W3F1-2017-0010

Subject: Response to NRC Request for Additional Information Regarding License Amendment Request to Revise Technical Specification 3/4.3.2 to Relocate Surveillance Frequency Requirements for Engineered Safety Features Actuation System (ESFAS) Subgroup Relays to the Surveillance Frequency Control Program (SFCP)
Waterford Steam Electric Station, Unit 3 (Waterford 3)
Docket No. 50-382
License No. NPF-38

**Response to NRC Request for Additional Information
Regarding License Amendment Request to Revise Technical Specification 3/4.3.2 to
Relocate Surveillance Frequency Requirements for Engineered Safety Features
Actuation System (ESFAS) Subgroup Relays to the Surveillance Frequency
Control Program (SFCP)**

Figure 1 (Portion of Drawing B424, Sheet E1646)

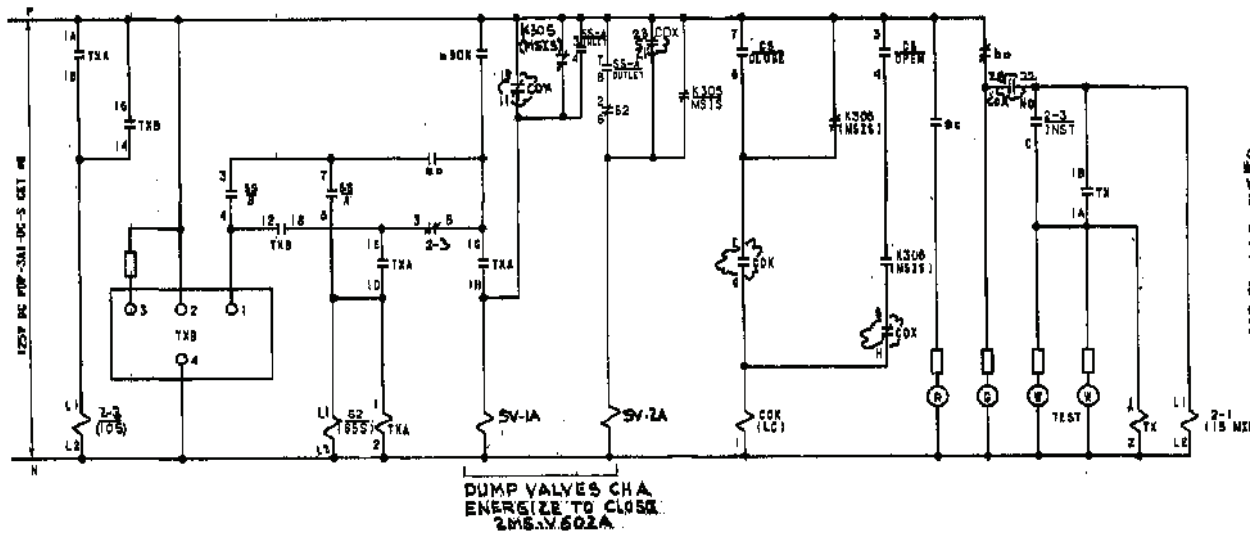
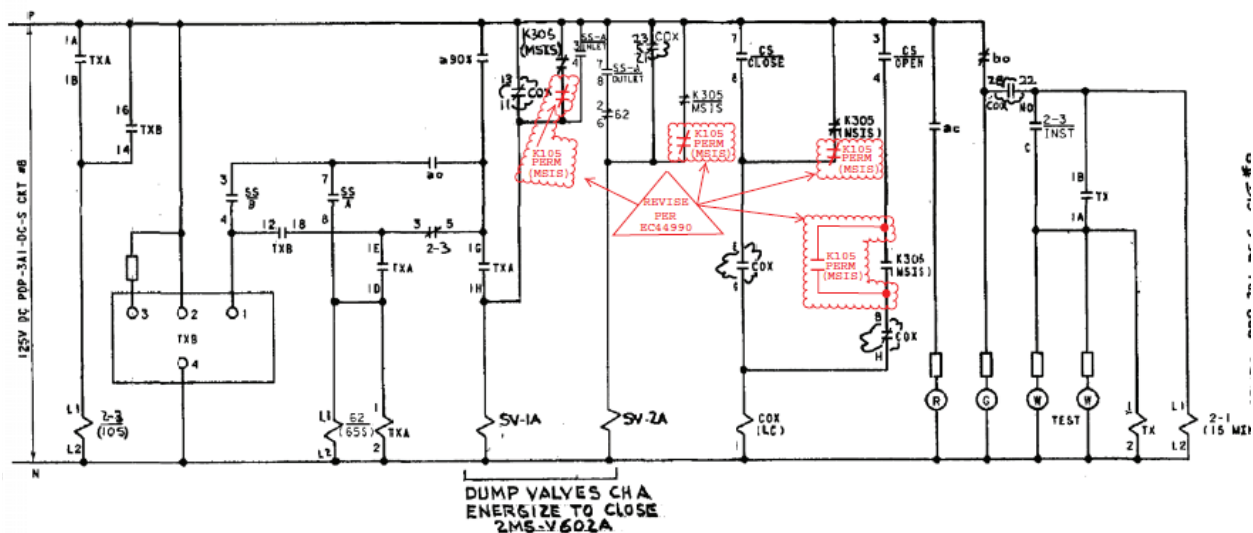
The NRC staff understands that the current circuit design does not permit inservice testability, and that the current design was granted an exception to Title 10 of the Code of Federal Regulations (10 CFR) Part 50, Appendix A, General Design Criterion (GDC) 21, "Protection system reliability and testability," and Institute of Electrical and Electronics Engineers (IEEE) 279-1971, "Criteria for Protection Systems for Nuclear Power Generating Stations," by invoking Section D.4 of Regulatory Guide (RG) 1.22, "Periodic Testing of Protection System Actuation Functions" (ADAMS Accession No. ML083300530), as supported by References 7, 8, and 9 in the application dated September 1, 2016. The current exception does not apply to the proposed design, which contains two contacts in each circuit, such that actuation of any one of the relays will not result in an ESFAS component actuation. If a spurious actuation of one relay during testing does not result in an ESFAS actuation, then the proposed design would permit inservice testability, and testing of the relays need not be limited to periods of cold shutdown. Demonstrate that the existing relay, within the proposed new configuration, will meet the surveillance requirements of GDC 21 and IEEE 279-1971, or fully justify why the surveillance of this existing relay should be granted an exception to GDC 21 and IEEE 279-1971 via the criteria outlined in RG 1.22, Section D.4.

The LAR, in part, supports the hardening of the ESFAS single-point vulnerability (SPV) by adding an additional contact in the Feedwater and Main Steam Isolation actuation by Main Steam Isolation Signal and Component Cooling Water Containment Isolation Valve Closure actuation by Containment Spray Actuation Signal. Provide circuit diagrams of both the current configuration and proposed modification, which demonstrate that the configuration will meet the requirements of IEEE 279-1971 as it applies to the likelihood of spurious actuation during testing. Specifically:

One of the Main Steam (MS) system safety functions is to isolate the Steam Generators from the non-safety portions of the MS system during emergency conditions by automatic closure of the Main Steam Isolation Valves (MSIVs). The automatic closure of the MSIVs occurs during MSIS. The MSIS is a signal generated by the ESFAS as a result of low steam generator pressure or high containment pressure. The MSIS actuates MSIVs, MS sampling valves, main feedwater isolation valves and emergency feedwater control valves. The current circuit design to close the MSIV utilizes normally closed contacts from the K305 relay shown in Figure 1 as it de-energizes during a MSIS.

The ESFAS actuation logic de-energizes the ESFAS subgroup relays upon ESFAS function actuation. The contacts from these relays provide a close signal to the MSIVs and associated feed train components. However, currently, a subgroup relay failure, ESFAS Auxiliary Relay Cabinet (ARC) power supply failure, a short circuit failure around the subgroup relay, or opening of a power supply circuit breaker may also de-energize one or more subgroup relays, depending on the nature of the failure, resulting in an unwanted and unwarranted closure of the MSIV(s) and associated feedwater train valves. If the Unit is at power when closure of a single MSIV occurs, then an asymmetric steam generator transient (ASGT) will occur, requiring intervention by the Delta TC algorithm in the Core Protection Calculator System (CPCS) to maintain the DNBR Safety Limit, resulting in a CPC Auxiliary Trip (reactor trip) on Low DNBR and High Local Power Density. If both MSIVs are affected (K305 and K313), then there will be a complete loss of heat sink, and the RCS pressure safety limit will be approached, requiring a reactor trip on High Pressurizer Pressure, or, at the very least, a Reactor Power Cutback.

The proposed design change will provide trip hardening of MSIS. This change consists of connecting the contacts of a presently unassigned MSIS relay (K105) in series (for normally closed contact actuation) or parallel (for normally open contact actuation) with those from MSIS relays K305 and K313. In the case for the MSIV as described above, the addition of normally closed contacts from the K105 relay will be installed in series with the K305 relay's normally closed contacts to energize the MSIV solenoid dump valves as shown in Figure 2.

RG 1.22 defines “actuation devices” as a component or assembly of components that directly controls the motive power (electricity, compressed air, etc.) for actuated equipment, and cites the following examples of an actuation device: a circuit breaker, a relay, and a valve (and its operator) used to control compressed air to the operator of a containment isolation valve. In the case of MSIV MS-124A, the actuation device consists of the K105 and K305 relays, at least one solenoid dump valve SV-1A or SV-2A, and the power to the circuit.

Testing of the function of the ESFAS (the protection system) to perform actuation of the MSIV includes testing of the actuation device (K105 and K305 relays, solenoid dump valve, and electrical power to the circuit) and actuated equipment (the MSIV).

The post trip hardening modification required surveillance will be performed similarly to the existing surveillance that is performed on the above circuit with the exception that the test position will be selected to de-energize both the K305 and K105 relays, resulting in energization of the solenoid dump valves, and subsequent MSIV closure. Closure of the MSIV while the reactor is at power is not desirable due to the increase in plant risk. Energization of one of the dump valves has the direct effect of draining the hydraulic fluid from the MSIV actuator, therefore this cannot be performed when the reactor is at power. De-energization of both relays simultaneously has the effect of energization of the solenoid valves, therefore this cannot be performed when the reactor is at power. The design does not include the allowance for testing the complete actuation device while preventing the operation of the MSIV.

The test circuitry includes a test position for selection of either of these relays individually. This test will only de-energize one relay and will not result in the actuation (closure) of the MSIV via the dump valves. This can be performed online; however, this test does not constitute testing of the actuation device. Testing the circuit online only verifies the relay contact changes state and would not actuate the solenoid dump valves to provide the necessary closure of the MSIV.

Generic Diagram of System Configuration After Change
(ESFAS Auxiliary Relay Cabinet Simplified Schematic Diagram for a Typical Actuation Signal)

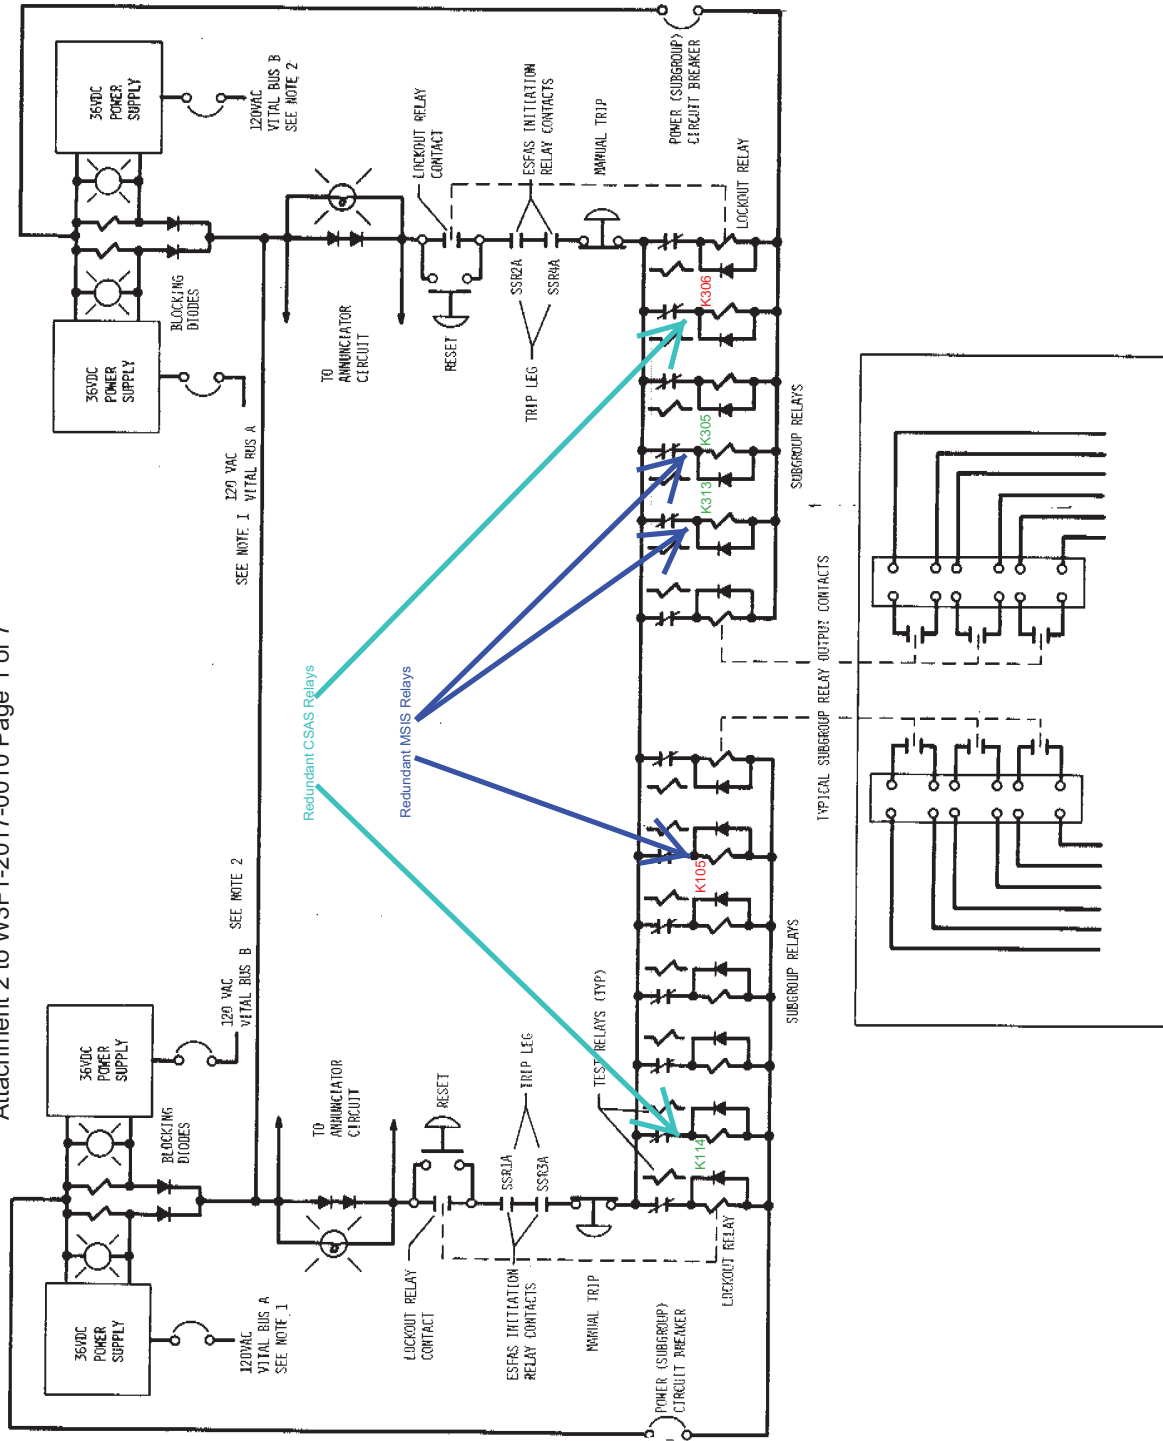
- a. Demonstrate that the power supply to these relays (with the new contact wiring) is independent of the power to the existing relays that are wired in the circuits to ensure trip hardening due to SPV.
- b. If the direct current (DC) power source is interconnected at one or more points, then explain how the power supply independence is maintained (e.g., is the power floating or grounded).
- c. Have any new features (e.g., a toggle switch) been added to the circuit design to facilitate testing?

The modification is designed such that each redundant relay is powered from the alternate power bus such that no failure on the alternate bus results in a loss of power to the redundant pair. A short circuit, ground, or open breaker will not de-energize the redundant pair. This is shown in Attachment 2, page 1 (Generic Diagram of System Configuration After Change), page 2, (drawing G1321), and page 3 (drawing G1322). This therefore demonstrates that the power supply to these relays is independent of the power to the existing relays which ensures that the circuits are trip hardened from SPVs.
